COLTS NECK CLUSTER ASSOCIATION

At its meeting of September 13, 2016, the Design Review Board (DRB) took the following action on your submission:

Approved addition to cluster standards for front entryway ceiling lights in Colts Neck Cluster to include the following:

9.13.2016
Light Standard

Style #2 – Square

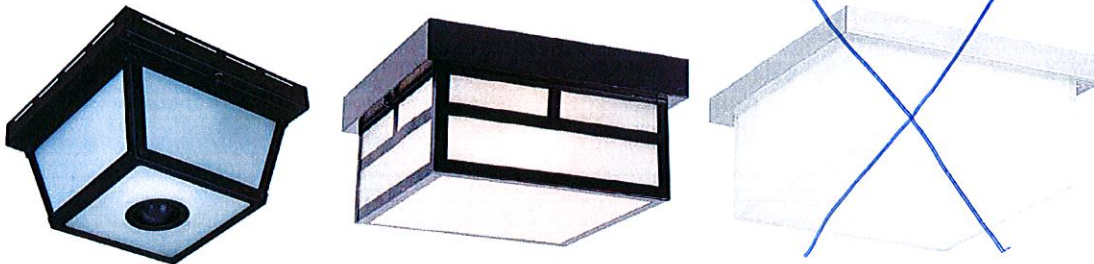
- Flush mounted or recessed
- Black, silver, bronze, or brass finish
- Oriented downward
- Opaque (milky white) or frosted glass (no glass required for recessed)
- Maximum dimensions of 16" w x 16" l x 10" h
- Octagonal, square, rectangular, or round shape, or recessed
- Examples as shown or similar, excluding the third example in option 2 (square shape, frosted glass, silver base, no framing, industrial style)

The Design Review Board notes that the third option in style #2 (square shape, frosted glass, silver base, no framing, industrial style) is specifically not approved.

with the stipulation that the light be a residential style, not industrial.
